RICHARD L. MEEHAN

Re: Dairi Prima Minerals (DPM) Mine site risks and Tailings disposal safety.

Summary: Based on information available, and without a site visit, I provide comment on tailings dam stability risks associated with the Dairi Prima Minerals (DPM) mine in Dairi Regency, North Sumatra.

Figure 2. View of author's estimate of tailings

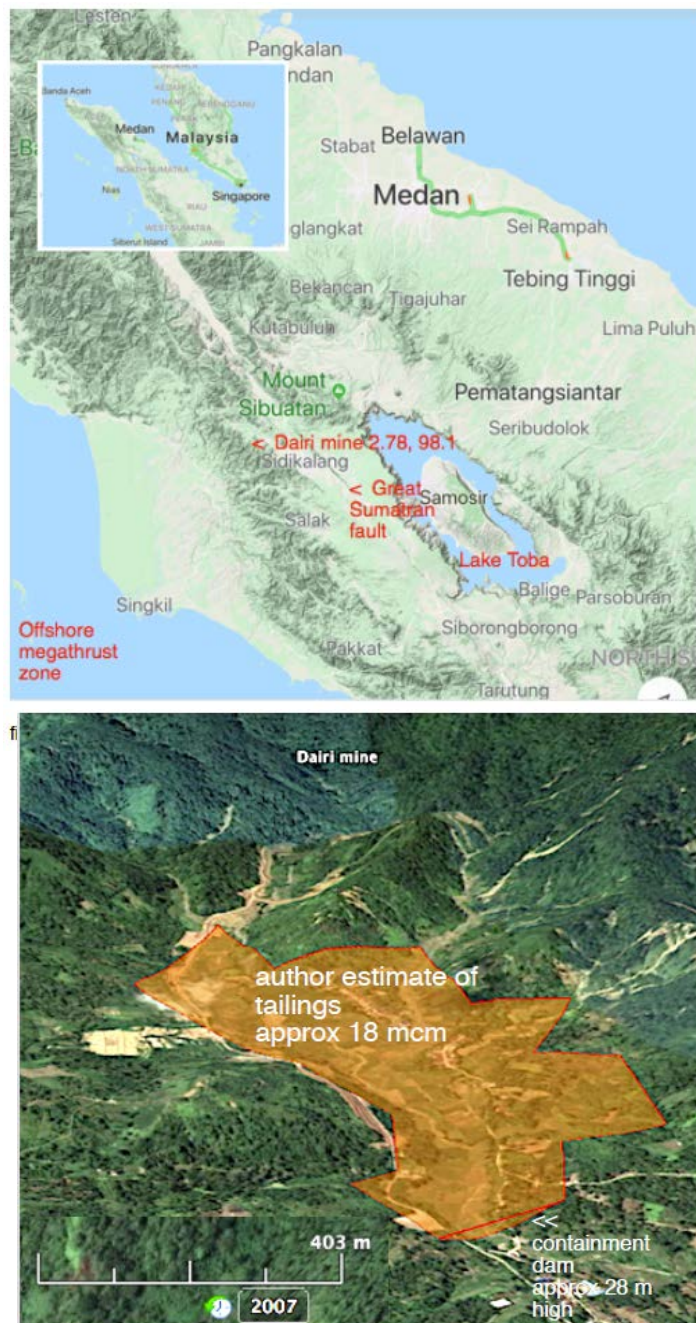
For the current 30 mt plan, I estimate the volume of above-ground storage for the waste slurry would be on the order of 10 mcm. Additional volume would be required to hold stormwater and landslide debris (see below) and whatever freeboard (reserve storage) is required for safety. Altogether my working estimate for full capacity of the storage facility is about 18 mcm. If this is correct, that would require a tailings facility as shown in figure 2. Note that this estimate assumes complete success in the paste backfill plan, which as yet has not been demonstrated in terms of economics (millions of tons of expensive cement will be needed), technical aspects (a successful recipe has not been shown) or safety (the paste backfill could increase the possibility of toxic chemical leakage from the abandoned mine into the environment).

Figure 3. Historical earthquake (Hayes, et al., 2013)

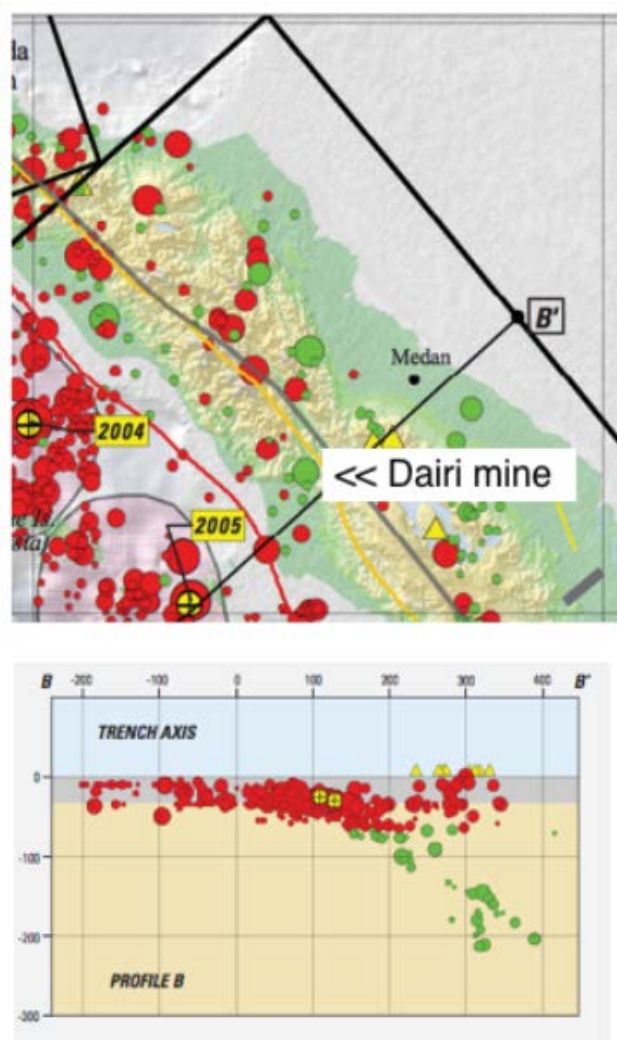
The mine is located in one of the world's most active earthquake regions, along the Sumatra subduction megathrust apparently near a triple plate junction which produced in 2004 and 2005 earthquakes of magnitude 9 and 8+ respectively (fig 3). These events rocked buildings as far away as Bangkok and produced intense regional damage including to road embankments and bridge abutments, which are similar in their behavior to tailings dams. Intensity of ground motion produced destruction of facilities at Banda Aceh, which is a comparable distance from the earthquake to the Dairi mine. Japanese investigators (see Sorenson et al., 2007) found that damage was up to about level 6, Japanese JMA scale. This damage category (6.0-6.4) produces these effects:

A map and cross section showing historical earthquakes is extracted from a comprehensive summary of seismicity of the area published by the US Geological Survey (Hayes, et al., 2013). This map and many other publications provide comprehensive information on regional seismicity sufficient to evaluate earthquake risk.

figure 5. Tailings dam very close to Sumatra fault with likely earthquakes up to M 7.5-7.9 and ground accelerations of 100%g

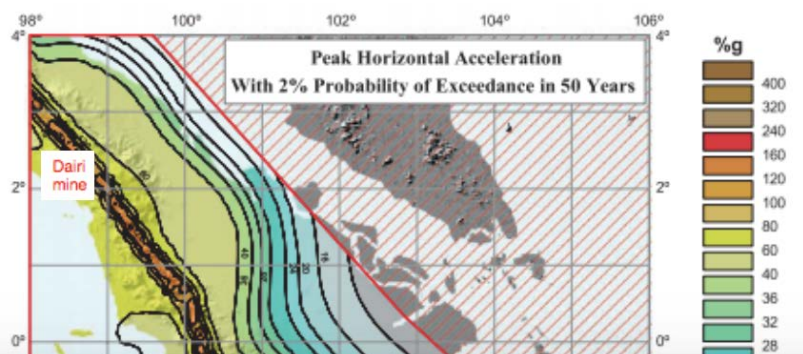
Although the offshore subduction zone mega earthquake poses a threat to long-period structures like tailings deposits, a more dangerous type of earthquake can be expected from the Great Sumatra fault which breaks ground only 15 km to the east of the Dairi site. According to Peterson et al (Ref Petersen et al., 2004) and others this fault is capable of generating earthquakes up to magnitude 7.5 to 7.9 and at this close distance are likely to produce very high ground accelerations on the order of 50-100% gravity (Figure 5).

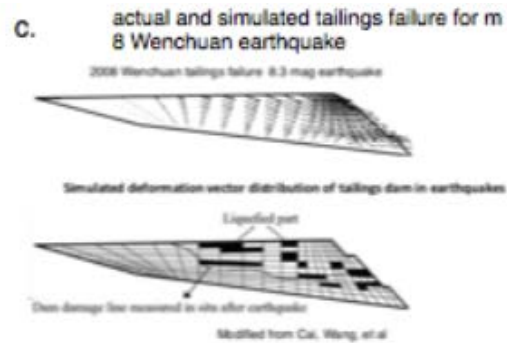
Failure of the containment for wet tailings would be most dangerous in the wet season with an abundance of water added to the containment. Cracking and sliding of the retaining structure would initially take on the appearance of the partial failure of the San Fernando dam, figure 6b (Castro et al 2003). But the San Fernando dam was subjected to only a few seconds of strong shaking. Larger earthquake from m 7.5 to 9 would produce shaking that would be much longer in duration with cracks and sliding of many meters in even robustly built dams. This would open the embankment to through flow of water and wet tailings, which would breach the Dairi containment (as in the Baldwin Hills Reservoir shown on video at <https://www.youtube.com/watch?v=c4sm7DdIMkk>) and also the Brazilian Brumadinho Mine.
